Project
Littleborough Family Hub Conversion
Calderbrook Road
Littleborough OL15 9JN

Title
Staircase 1
Plan, Section & Details

Drawn IRD	Checked and Approved AMR	Safety Audit Check ★
Scale 1/50 @ A1	Date 26/08/2025	
Dwg No. A1/ 2005021/BS/019D

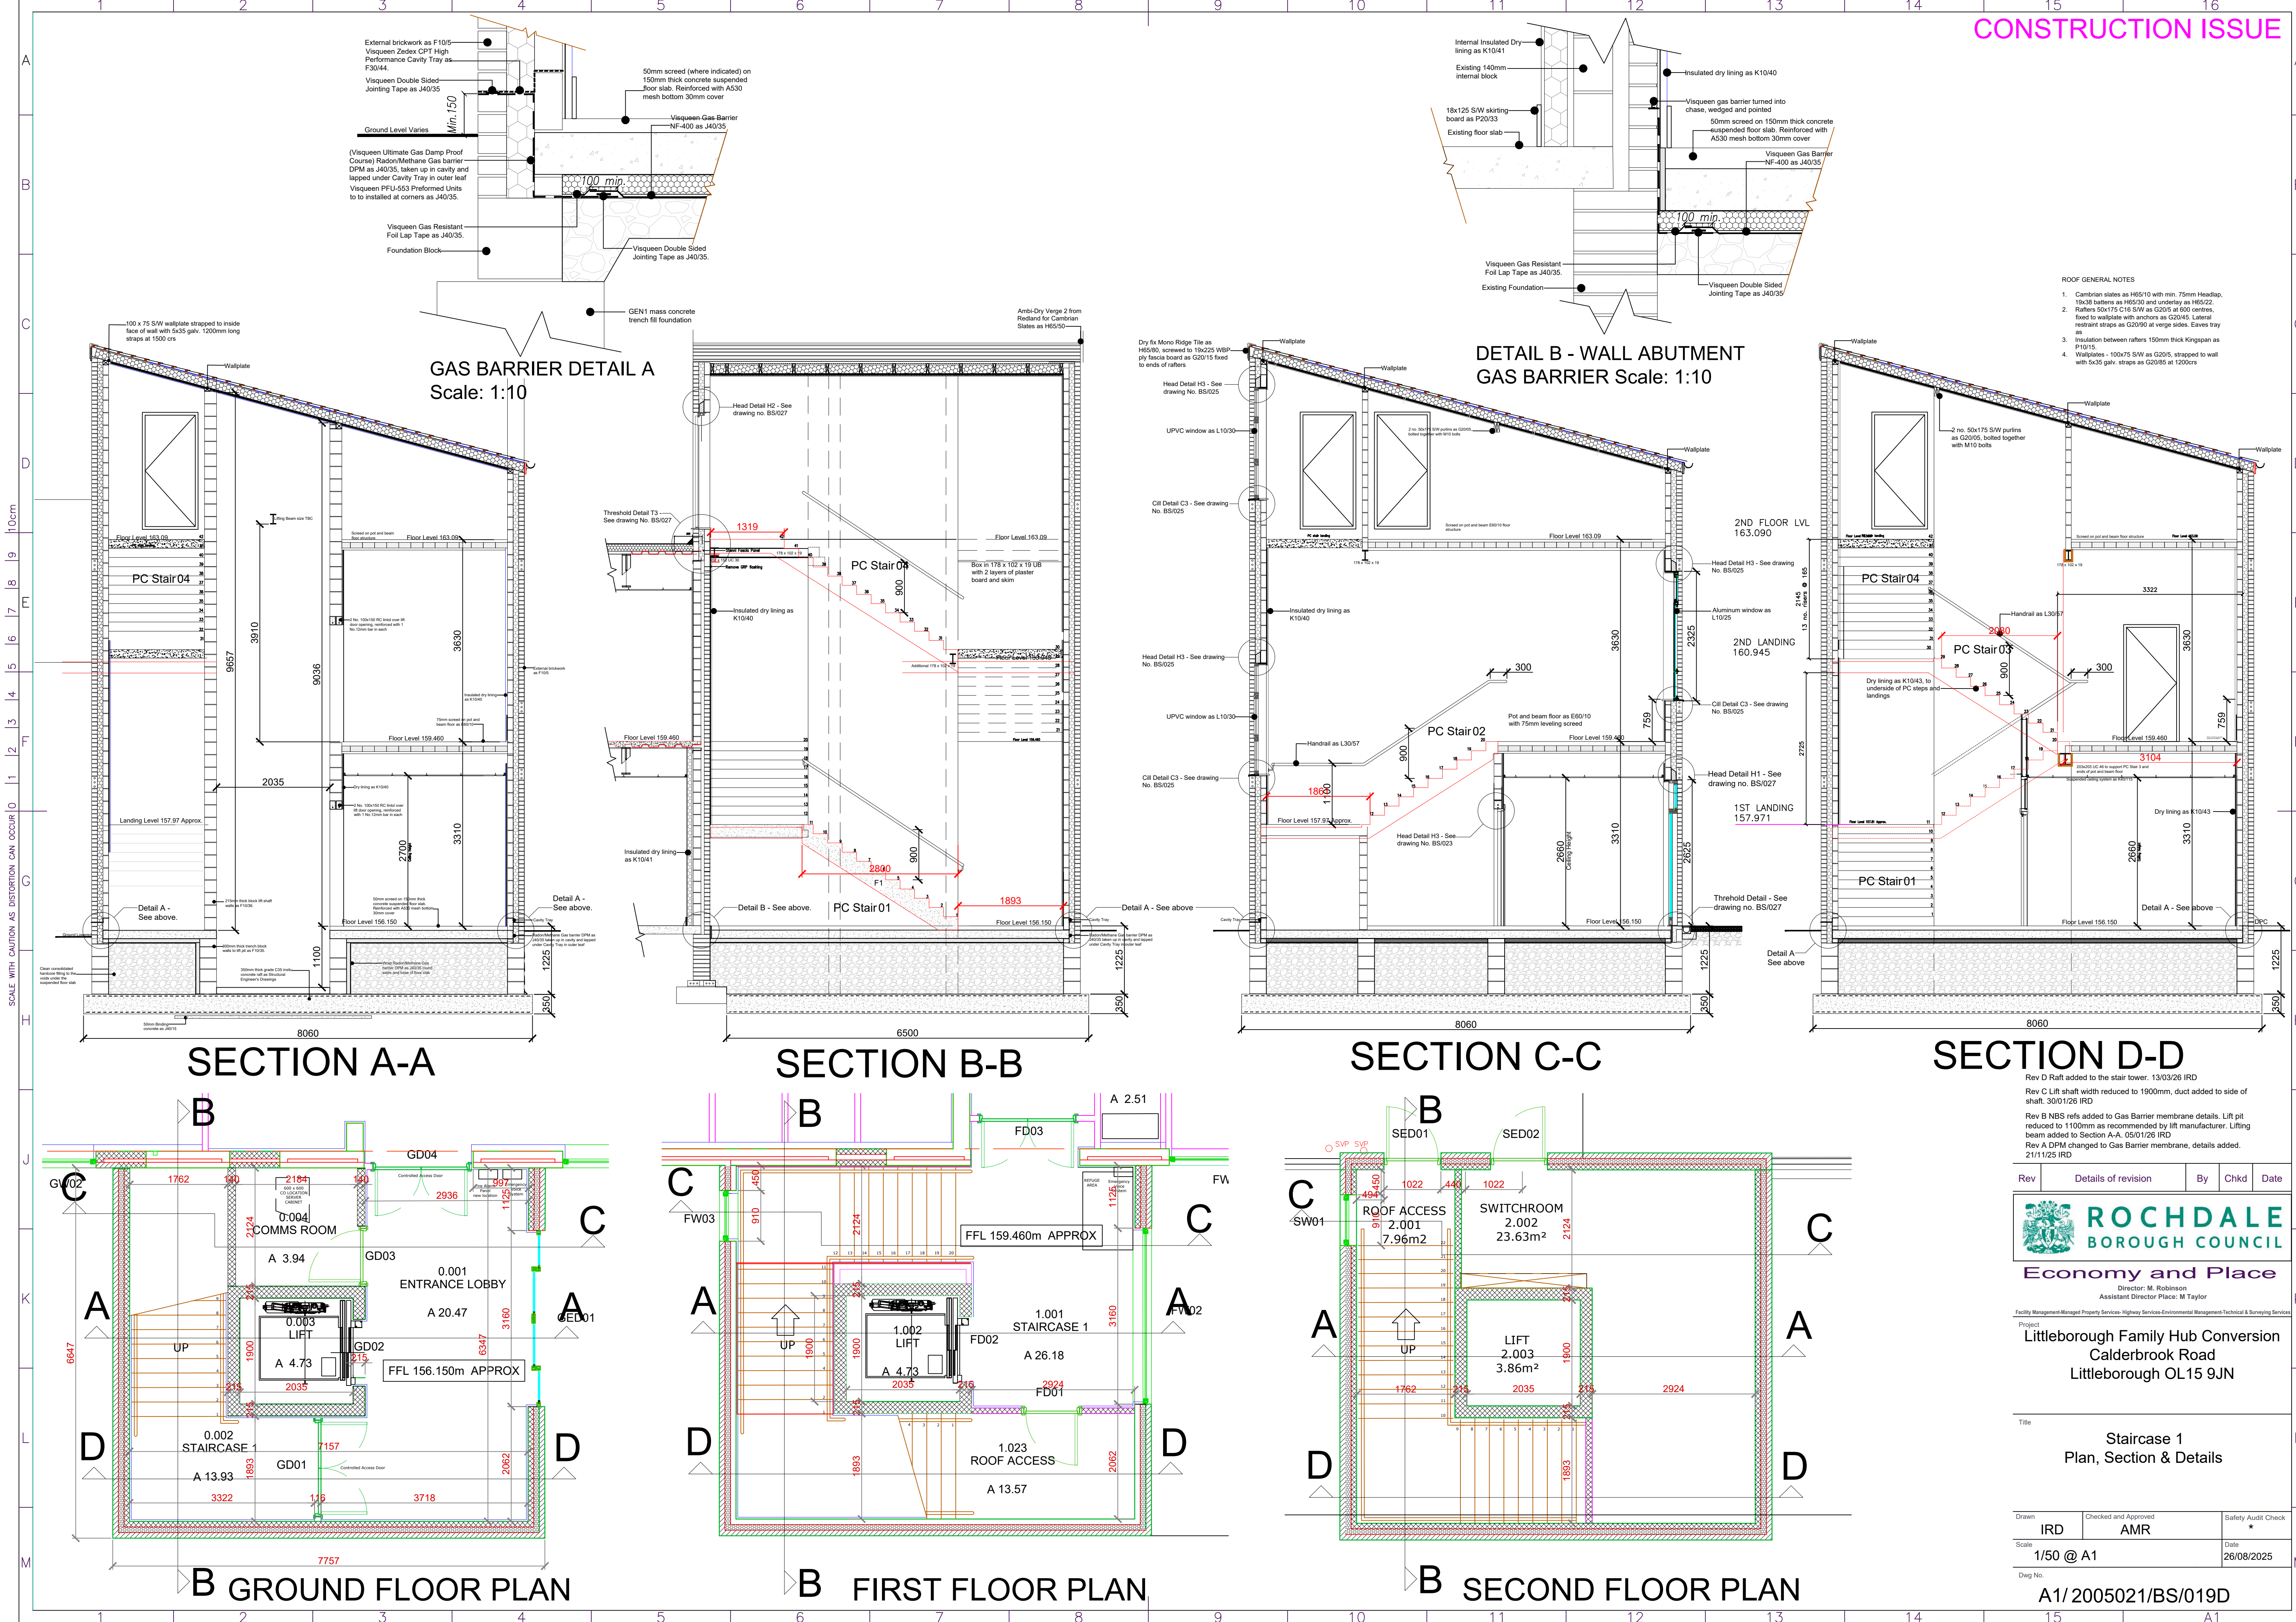
- Rev D Rafter added to the stair tower. 13/03/26 IRD
- Rev C Lift shaft width reduced to 1900mm, duct added to side of shaft. 30/01/26 IRD
- Rev B NBS refs added to Gas Barrier membrane details. Lift pit reduced to 1100mm as recommended by lift manufacturer. Lifting beam added to Section A-A. 05/01/26 IRD
- Rev A DPM changed to Gas Barrier membrane, details added. 21/11/25 IRD
